Item Name: Crosstube Turning Detail

DART AEROSPACE LTD		Work Order:	93993
Description: Crosstube Assembly (205/212/412 High Fwd)		Part Number:	D212-664-141
Inspection Dwg: D212-664-141 Rev: D		Page 1 of 2

**D212-664-141/-141B
ASSEMBLY DETAIL**

DRAWING NO. D212-664-141	TITLE XTUBE ASSY (205/212/412 HI FWD)	REV. D	DART AEROSPACE LTD ENGINEERING ORDER		D.E.O. NO. D212-664-141-D-1	SHEET NO. SHEET 1 OF 2	SCALE NTS
DRAWN	CHECKED	MFG. APPR.	APPROVED	DE APPR.			
DATE 11.04.07	DATE 11.04.11	DATE 11.04.12	DATE 11/04/12	DATE 11.04.12

**D212-664-141/-141B
ASSEMBLY DETAIL**

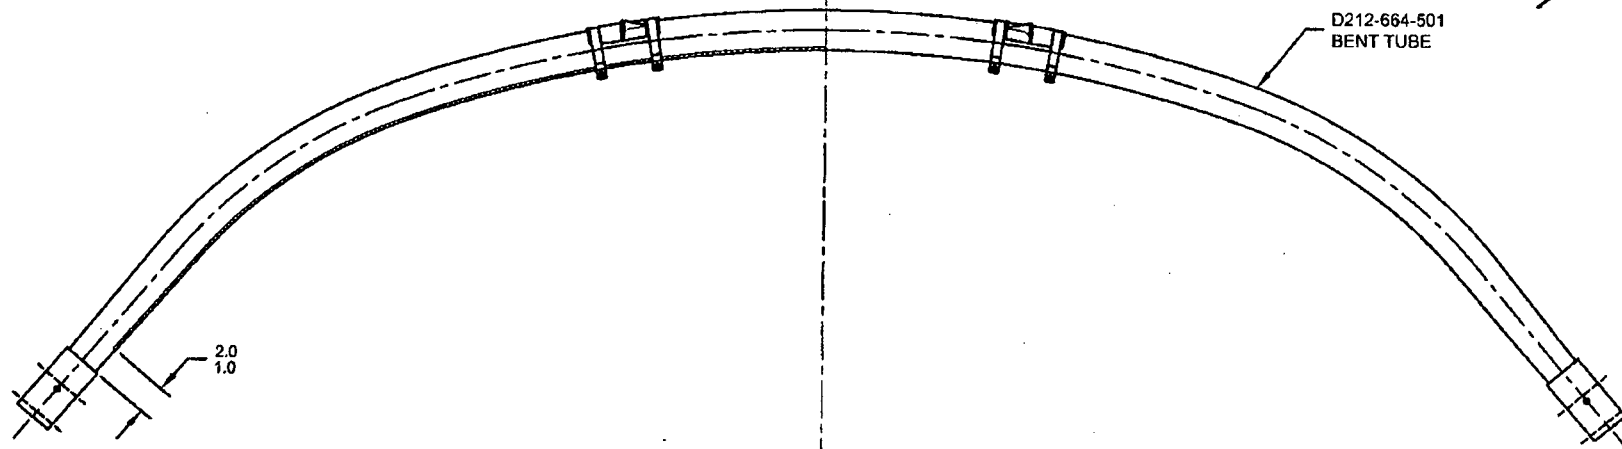
PURPOSE:

ADD AN INSPECTION WINDOW TO UNDERSIDE OF CROSSTUBE.

IS:

WAS:

MASK AREA PRIOR TO PAINTING,
REMOVE MASKING AFTER PAINT
AND APPLY CLEAR COAT

- 2) FINISH: CHEMICAL CONVERSION COAT PER DART QSI 005 4.1
PRIME INSIDE AND OUTSIDE PER DART QSI 005 4.2
MASK UNDERSIDE OF CROSSTUBE AS SHOWN (HATCHED AREA) AND
PAINT OUTSIDE PER DART QSI 005 4.2
REMOVE MASKING AND APPLY CLEAR COAT
